# Access Compliance Report

## Public Rights-of-Way

### (Pedestrian Signals)

Intersection ID: N/A	Main Street:	Cross Street: N/A	Location: N/A
ADA ID: DAE384D20046	Signal Type: One Push Button-Non APS	Overall Compliance: No	Severity Score: BTN 1: N/A BTN 2: N/A No BTN: N/A
Codes/Mitigation Info/Possible Solution		Field Measurements/Component Compliance

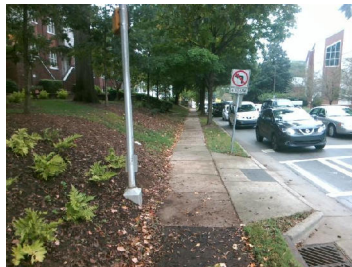
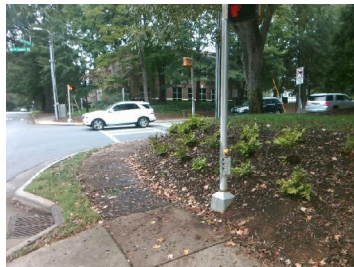
Yes	B 1 Clear Xing Direction?	ClearlyMarked	N/A	B 2 Clear Xing Direction?	N/A
	B 1 Crossing Direction	To SW		B 2 Crossing Direction	N/A
Yes	B 1 DistanceTo XWalk (in)	10.0	N/A	B 2 DistanceTo XWalk (in)	N/A
No	B 1 DistanceTo Curb (in)	130.0	N/A	B 2 DistanceTo Curb (in)	N/A
Yes	B 1 Diameter (in)	2.0	N/A	B 2 Diameter (in)	N/A

Possible Solutions: Replace Signal Push Button With APS Button on New Post. Remove & Relocate Sign.
